CITY OF BELOIT
OFFICE OF THE CITY CLERK**RESOLUTION 2020-043****RESOLUTION AUTHORIZING A PLANNED UNIT DEVELOPMENT (PUD)
MASTER LAND USE PLAN FOR THE BELOIT SNAPPERS STADIUM REDEVELOPMENT**

Topic:	Planned Unit Development (PUD) - Master Land Use Plan for 202, 217, 220, 232, & part of 225 Shirland Avenue as well as 55 & part of 101 Water Street		
Date:	March 16, 2020		
Presenter:	Julie Christensen	Department:	Community Development

Riverbend Stadium Planned Unit Development

Re: PUD Review Comments to be Incorporated into Final PUD (Site) Plan

Illustrated Site Plan

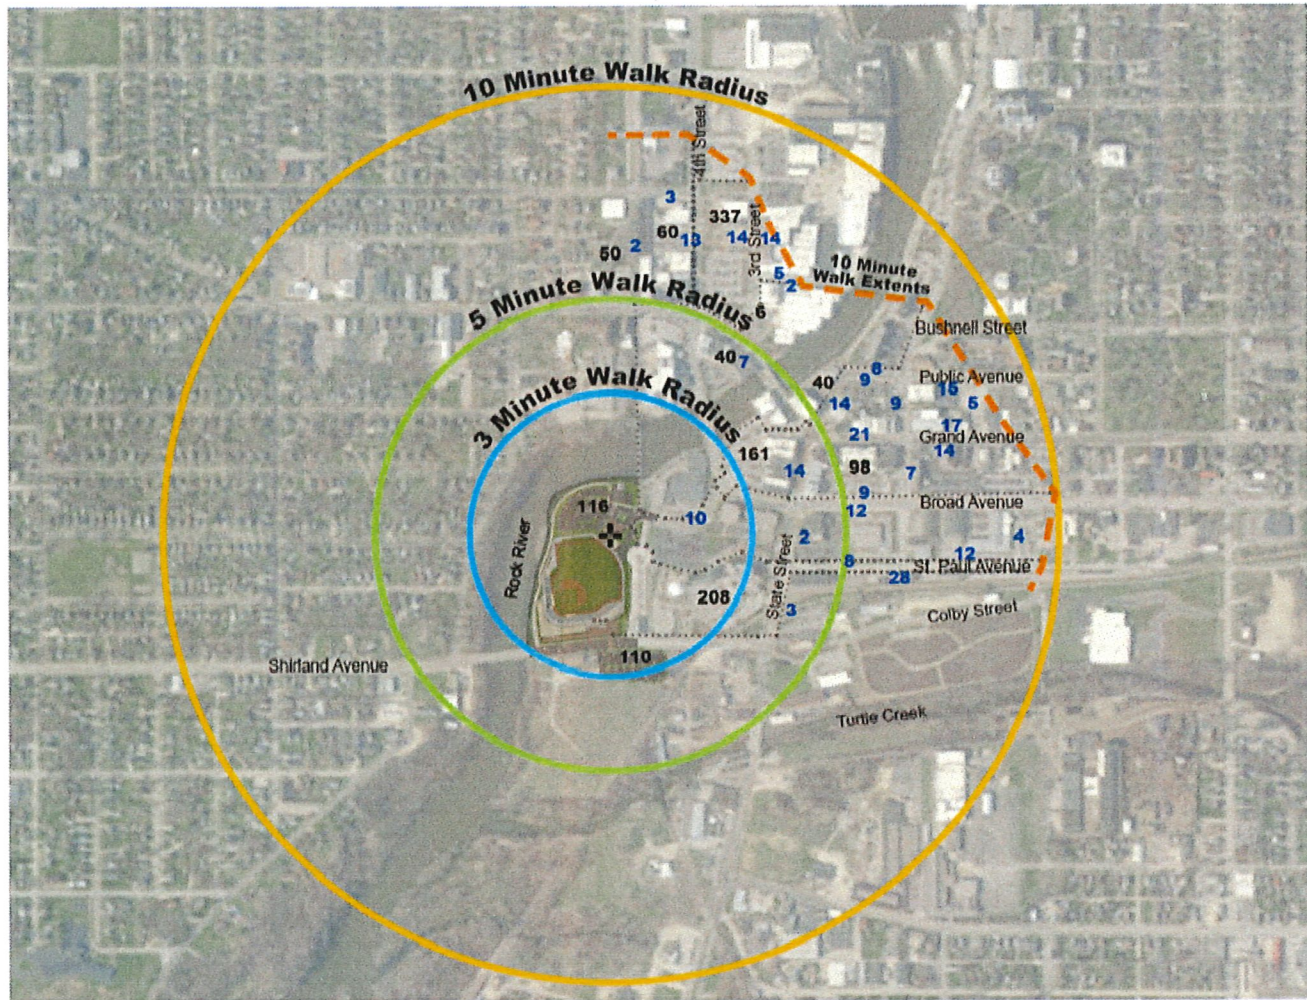
- Note that PUD approval will be contingent upon execution of Lease and street vacation
- Street Vacation (recording thereof) will be contingent upon execution of Lease
- For clarification purposes, please identify the multi-use path as open to the public
- A Chapter 30 Permit is required from the Wisconsin DNR due to the proximity to the Rock River and should be factored into the review timeline
- Show the Base Flood Elevation and floodplain limits on the site plans
- Bollards with emergency operability are required at Shirland entrance to multi-use path
- The playground label (#23) is mislabeled as #13
- Change the proposed zoning to PUD and not Central Business District
- Please identify the bike rack locations at all major entrances to the stadium

- Where will the Contractor stage equipment and materials and where will workers park during construction of the project? Identify on phasing plan.
- Will this development be requesting any public road or lane closures (other than the vacated portion of Water Street)? If so, detour plan is required.

- Is the curb cut on Shirland Avenue adjacent to the right field entrance intended to be used for vehicular access or is this only for pedestrians?
- This development will ultimately require a right-of-way permit for all work being performed in the right-of-way.

- The State line should be clearly indicated on the site plan.
- If the development is going to be connecting to existing storm sewers, the designer must demonstrate that the existing storm sewers have the capacity to convey the added storm water in a 10 year storm event. If there is not enough capacity either the existing storm sewers will need to be upsized or a new outfall will need to be constructed.

- The shared use path shall be reconstructed at 10 feet wide as shown and should also contain a 2 foot wide clear zone on either side of the path. This clear zone should not contain any obstructions including path lighting. The path shall have grass shoulders. Existing path lighting may be reused/relocated however new conduit and wiring will need to be installed. New lighting will need to match existing.

- The 10 foot wide shared use path along Shirland Avenue shall also have a 2 foot clear zone on either side with no obstructions. The plan indicates that this path will cross a couple of areas where a brick pattern hatching is indicated. This pavement may be colored but can't have any brick like or other texture (other than a broom finish). Spot elevations shall clearly be shown in these locations indicating that the cross slope of the shared use path will not exceed 2.00% in these locations.

- The plan submitted indicates that the parking lot for the northwest lift station is to be removed and replaced with a larger parking lot. This parking lot is in good condition and does not need to be replaced. In order to allow room for the badge reader for the automatic gate at this location, the driveway should be narrowed by four feet by moving the west edge of the driveway 4 feet to the east. This, combined with leaving the existing concrete parking area in place will allow room to install the badge reader and automatic gate in this location.

- Comment should be provided with respect to what vehicles will be accessing the area between the stadium and Shirland Avenue. Turning movement exhibits will need to be submitted showing that vehicles can maneuver in this area without needing to back into this area from Shirland Avenue.

- The pedestrian and bike crossings on Shirland Avenue and Water Street may contain colored pavement, but there shall be no brick like or other texture on the pavement (other than a broom finish).

- Stop signs will need to be placed along the shared use paths where they cross roadways.
- At the northeast portion of the site, south of Water Street, the shared use path should be pushed to the east and separated from the vendor drive. Again 2 foot clear zones should be maintained along the shared use paths.
